Product Change Notification

Change Notification #: 115459 - 01
Change Title: Intel® Tri Band Wireless-AC 18260
Skus: 18260.NGWG, 18260.NGWG.RF
and 18260.NGWG.RFS, PCN 115459-01,
Label, Label Update
**Reason for Revision: Enlarging the CE
logo**
Date of Publication: April 21, 2017

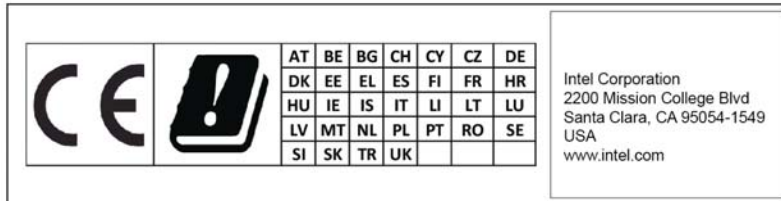
4. We will be adding 2 graphics to the outer packaging to be visible by EU customs.
 - a. A new CE graphic:
 - b. The Intel Corporate address
